ADDENDUM

Date Issued:	Feb 21, 2024
Project:	Intermountain Health Intermountain Kidney Services – West Valley Dialysis 2750 South 5600 West West Valley City, UT 84120
Addendum Number:	1

Date: 2/20/24
Project No: 22249
Project: IKS West Valley Dialysis
Revision: Addendum #1

- COVED SHEET VINYL BASE COLOR SHOULD CONTINUE THE SAME COLOR AS THE FLOOR SHEET VINYL. INSTALL ALUMINUM TRIM ON TOP OF COVED SHEET VINYL BASE.

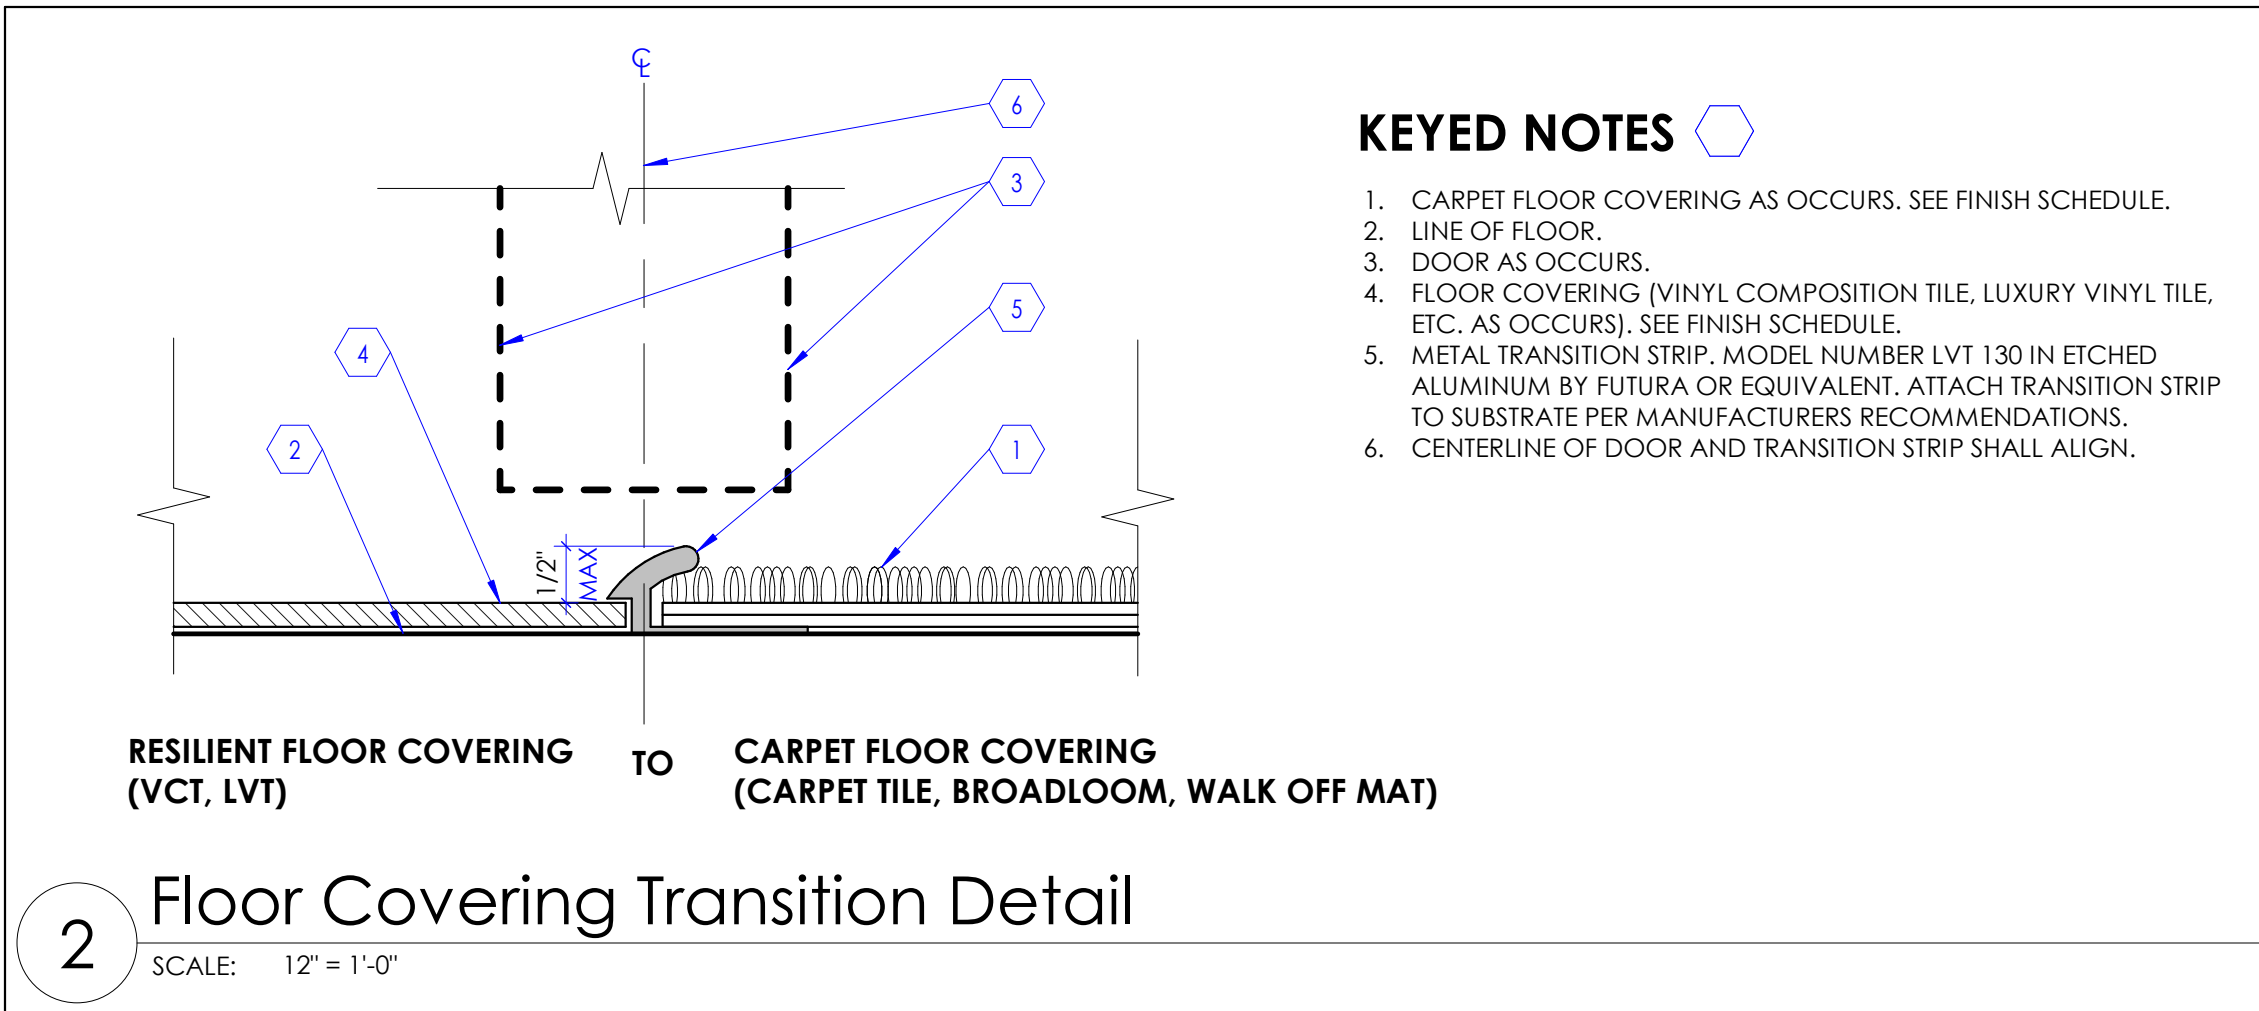
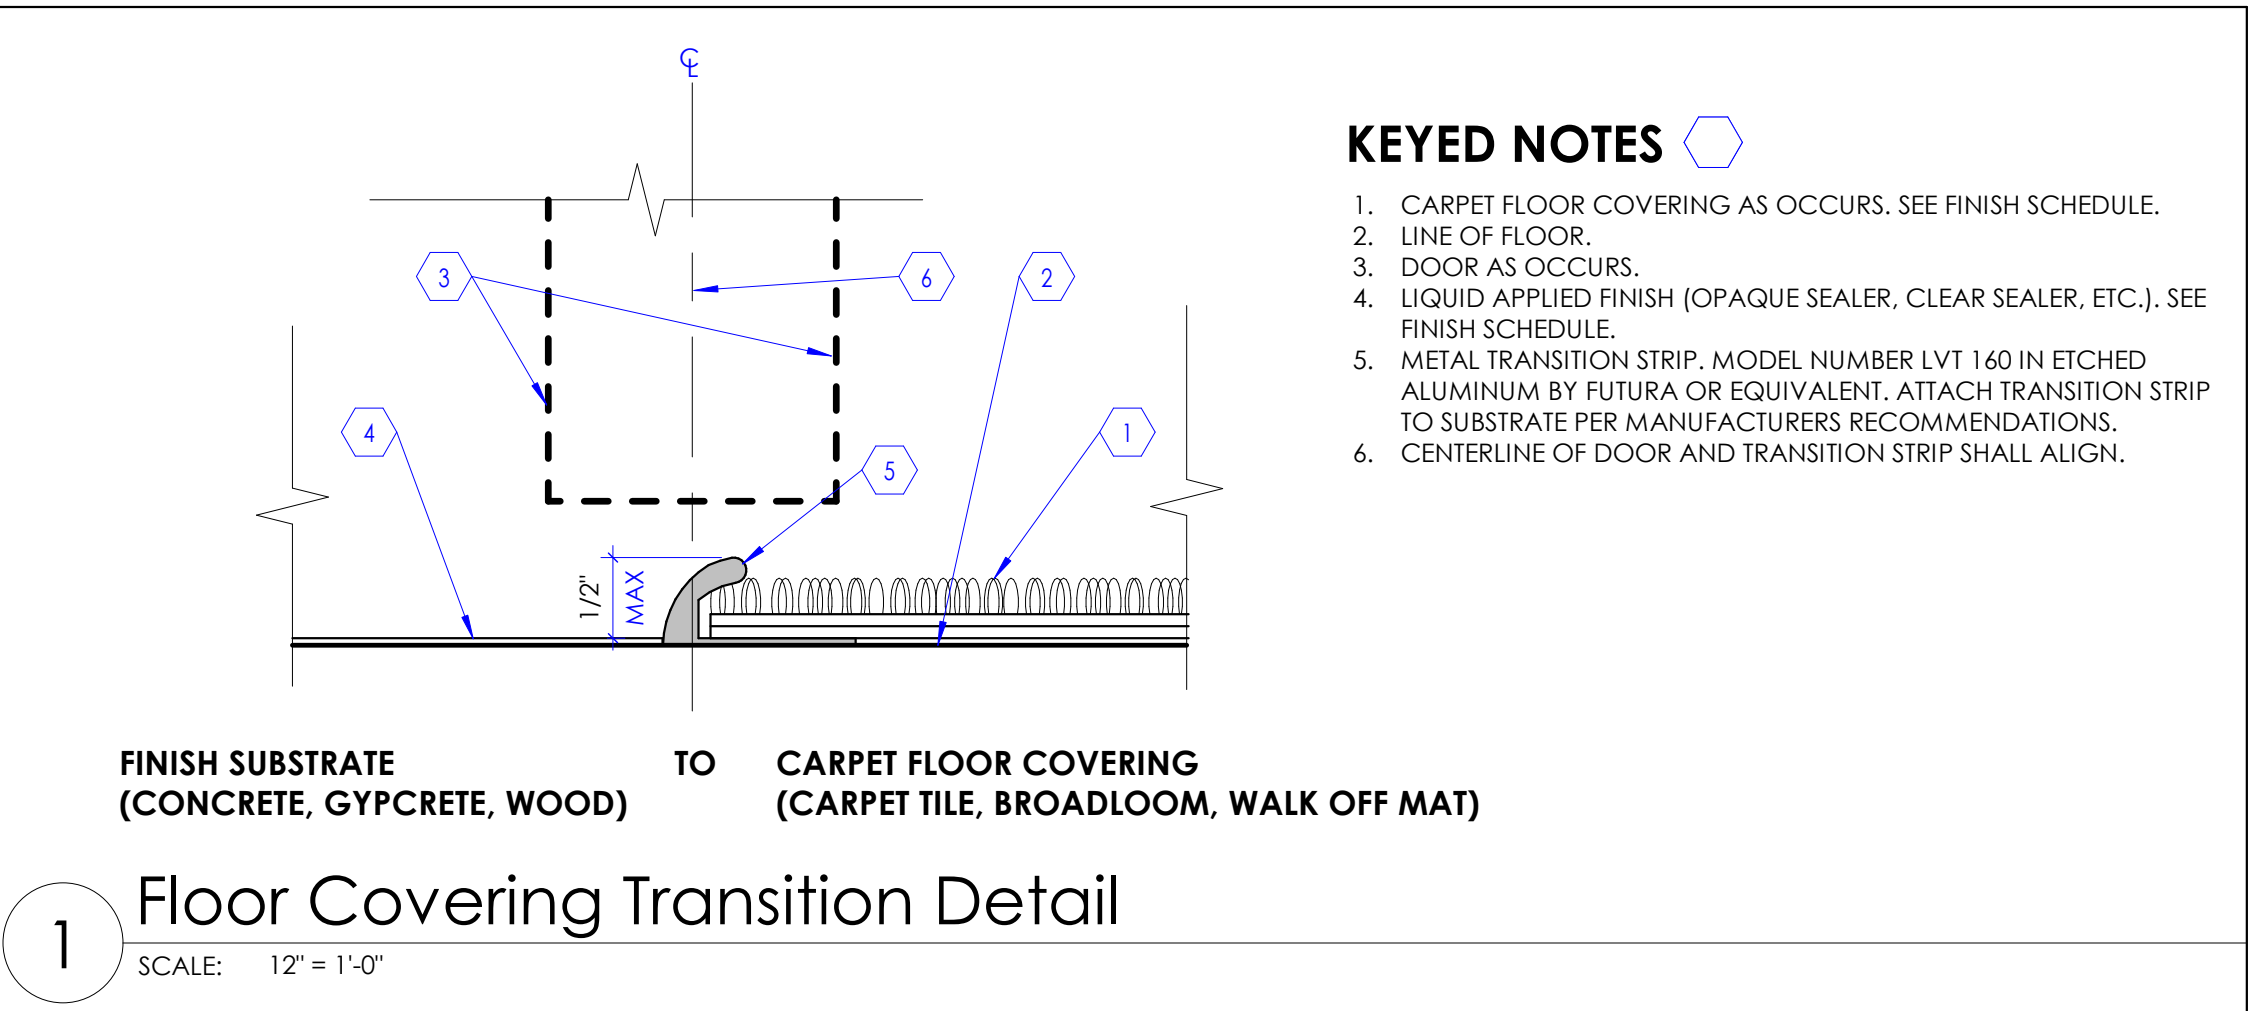
Item Number	General Items Description
	<p>Response: The one by the maintenance bypass is incorrect – the maintenance bypass is also OFCI as noted on the plan. UPS is OFCI – owner furnished, contractor installed. The keynote has been removed in Addendum #1.</p> <p>Question #6: One-line diagram is showing main breakers in all new panels but the panel schedules are calling Main Lug Only please clarify which will be required.</p> <p>Response: The man breakers shown in panels 1L1, 1L2, 1LE1, and 1LE2 are not required; these have been removed in Addendum #1.</p> <p>Question #7: The lighting control panel schedule doesn't show any of the circuits as dimming. Is this correct?</p> <p>Response: This is correct – this is not a dimming panel; dimming is by local switches where indicated in plan.</p> <p>Question #8: The tiles called out come in both honed and unpolished and do not specify which one. Can you please clarify? I noticed there was no tile trim or schluter called out on the plans, am i missing something or is it to be determined? thanks Will we be putting a schluter trim in any locations?</p> <p>Response: All of the ceramic tile should be the honed finish. As for the tile trim, we call that out in our spec. Section 093000 Tiling 2.13 Miscellaneous Materials K. 1. We have added clarifying information to the comments on the finish schedule.</p>

PLUMBING
PLAN LEVEL 1

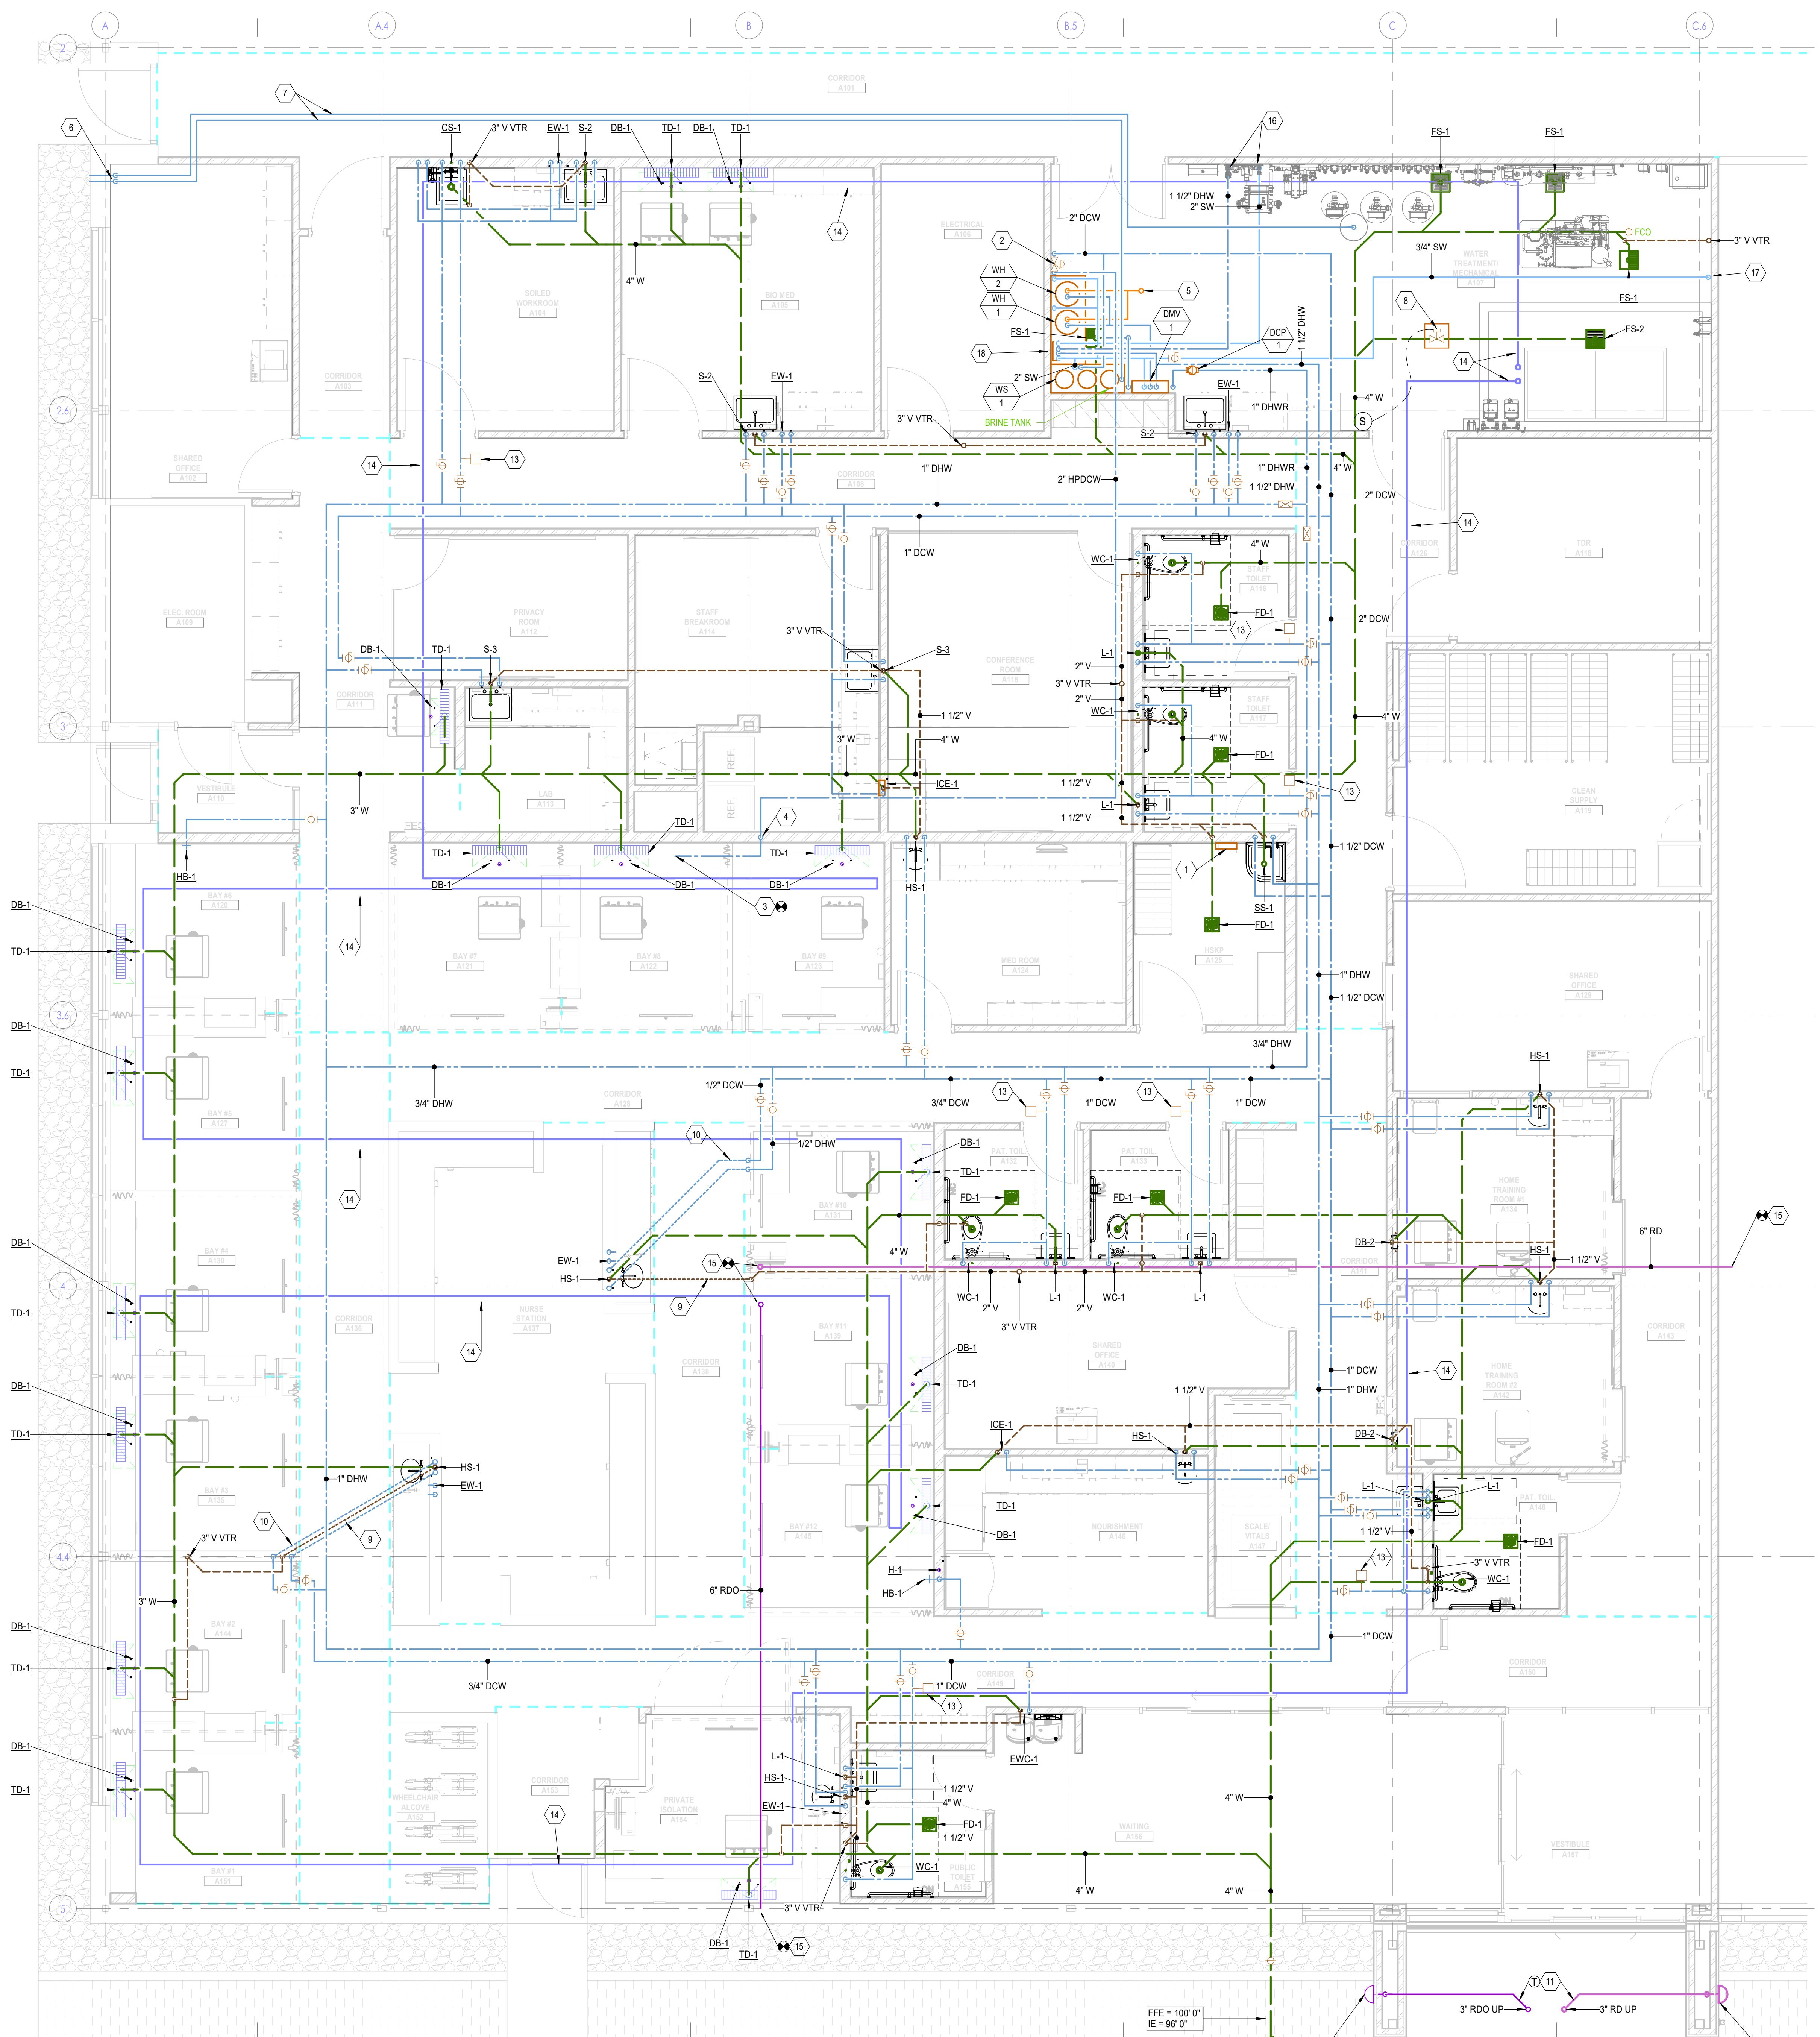
Sheet: PP101 - PLUMBING PLAN LEVEL 1

- KN 18 added.
- General Notes updated.
